ALERT SERVICE BULLETIN

NO. 212-00-109
DATE 10-19-00
PAGE 1 of 3

SUBJECT: MAIN HYDRAULIC SERVO ACTUATOR ROD
END LOCK WASHER, INSPECTION AND
REPLACEMENT OF

FLIGHT CONTROLS – HYDRAULIC SERVO ACTUATOR INSPECTION FOR DAMAGED LOCKING WASHER

Figure 1

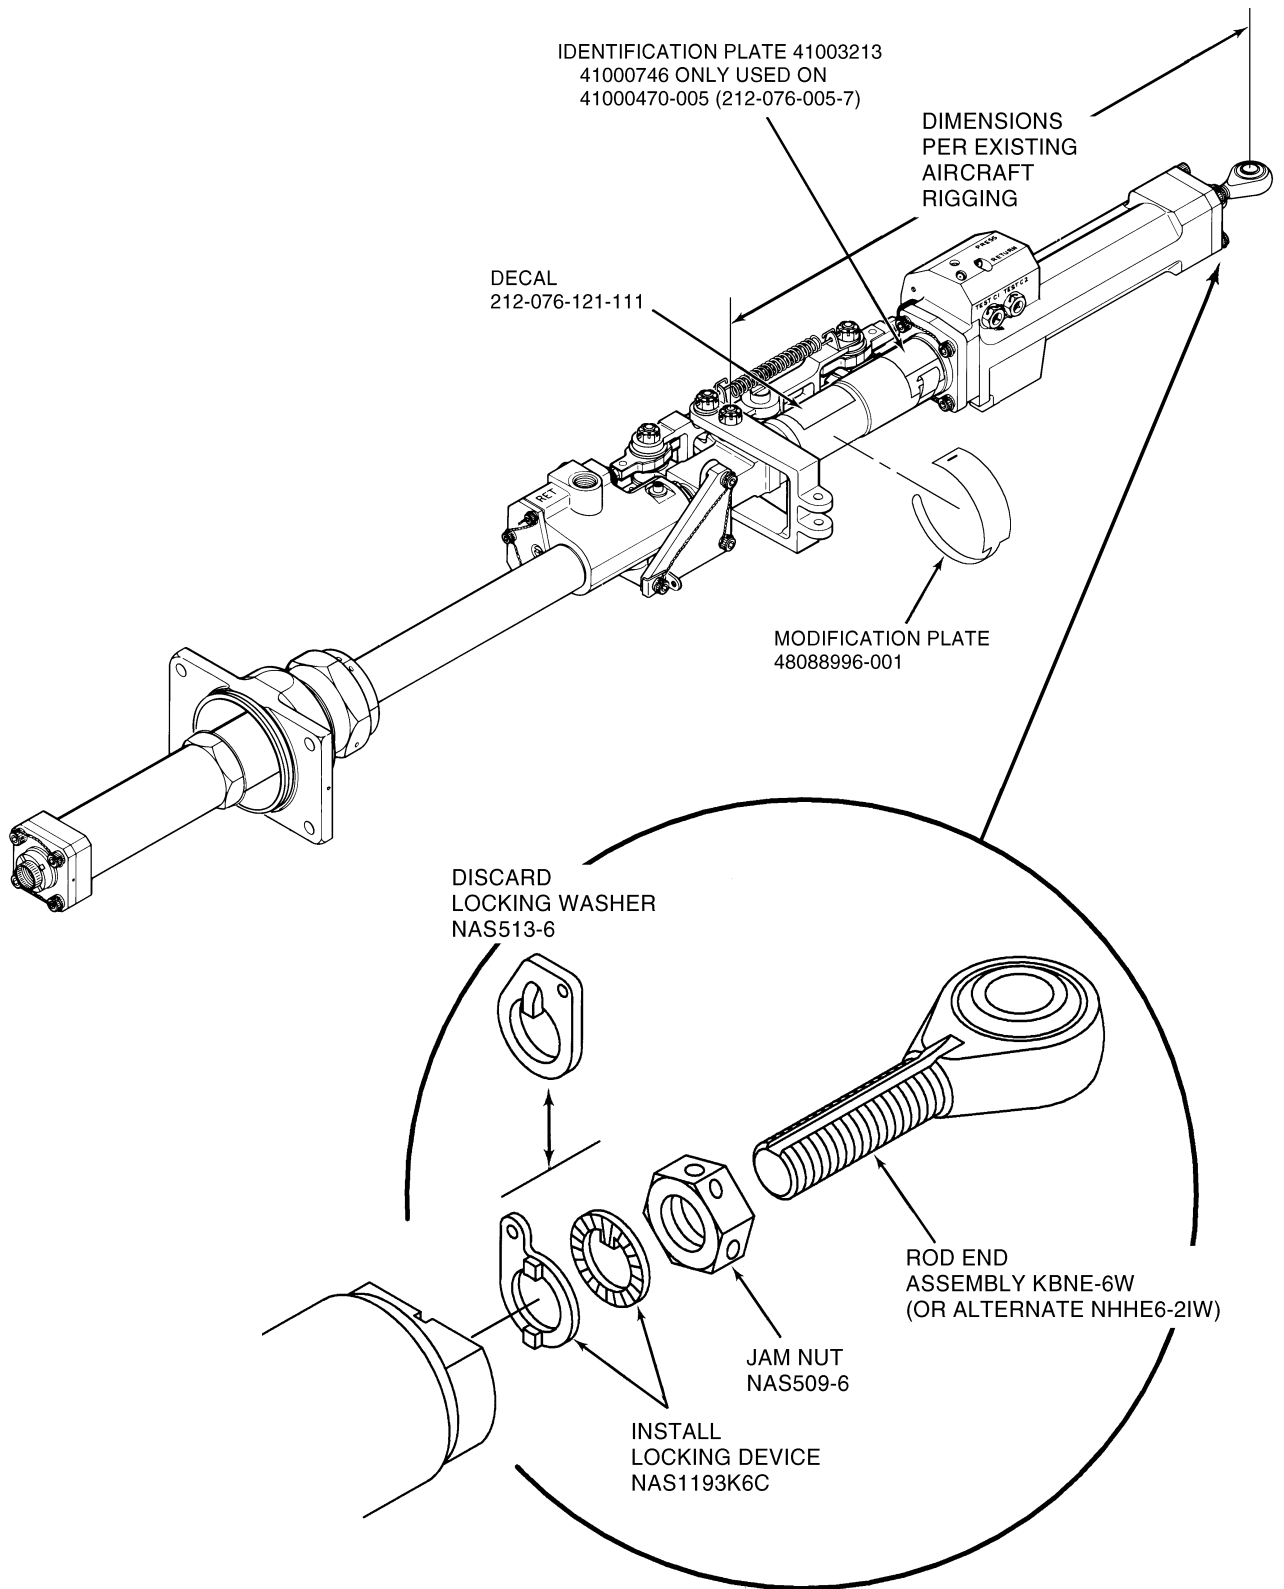
A customer recently discovered a damaged locking washer that had allowed the piston to back itself out of the locking jam nut (Figure 1). This condition prevented the aircraft from taking off and presented a Safety of Flight condition. Bell Helicopter's subsequent investigation determined that all existing locking washers NAS513-6 used on applicable actuators shall be replaced with new locking devices NAS1193K6C.

- (1) Without removing actuator from aircraft, gain access to locking washer (Figure 1).
- (2) Visually inspect locking washer to ensure it is not broken. Tab shall be in groove of rod end assembly. Immediately replace any locking washer whose tab is twisted or hanging askew.

- (7) Carefully install new 2-piece locking device NAS1193K6C onto rod end assembly. Refer to Figure 1 and the following substeps:
 - (a) Install round ring onto threaded rod so that tab fits into groove on rod end and serrated side faces away from jam nut.

- (b) Install oblong ring onto threaded rod so that serrated side will engage serrated side of round ring.
- (8) Install rod end assembly into threads of piston assembly. With piston assembly bottomed in cylinder assembly, establish the same dimension that was recorded in step 3.

- (9) Slide oblong ring (part of new locking device NAS1193K6C) so that two locking tabs fit into slots on end of piston assembly. Slide round ring (also part of new locking device NAS1193K6C) to engage oblong ring.
